AERONAUTICAL CHARTING MEETING Instrument Procedures Group Meeting – April 23, 2019

RECOMMENDATION DOCUMENT

FAA Control # ACF-IPG RD 19-01-342

<u>Subject</u>: Charting "NA WHEN LOCAL WEATHER NOT AVAILABLE" for Alternate Minimums

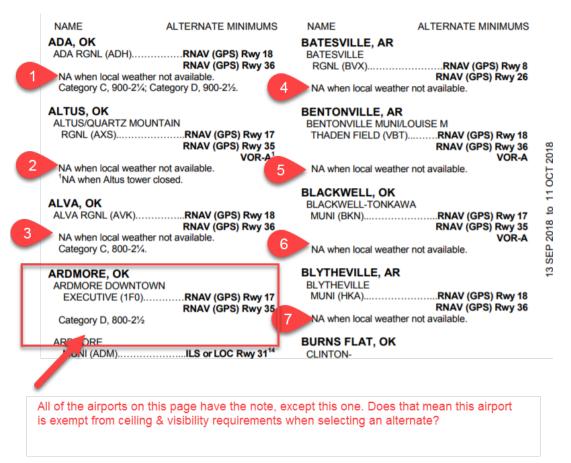
1. This note immediately causes the Alternate Minima approval to be non-standard, thus the "NA WHEN LOCAL WEATHER NOT AVAILABLE" note is inserted into the TPP Alternate Mins page. By itself, this would not be an issue, however **ALL non-standard alternate minimums and notes are <u>consolidated</u> in TPP. The resulting effect is that some airports will have this note, and others will not. This situation has led to pilots concluding that the airports and/or procedures that do not have this note are exempt from the ceiling & visibility requirement when selecting the airport as an alternate.**

Excerpt from Askacfi.com:

The way I read it, you can use the ILS, LOC, VOR/DME approaches for alternate minimum planning even WITHOUT local weather being available.

Here's the airport that was being considered: **DES MOINES, IA**

DES MOINES INTL ILS or LOC Rwy 5¹ ILS or LOC Rwy 13¹ ILS or LOC Rwy 31¹ RNAV (GPS) Rwy 5² RNAV (GPS) Rwy 13² RNAV (GPS) Rwy 31² VOR/DME Rwy 23³

¹Category E, 900-234. ²NA when local weather not available. ³Category C, 800-214; Category D, 800-21/2. Only the RNAV procedures have the LOCAL WEATHER requirement; therefore, this pilot concluded that ceiling and visibility was not required for alternate planning, which is not in compliance with 97.169. 2. When all airports and procedures with non-standard minimums are consolidated into a single product, this may lead to reasonable conclusions that are unintended.
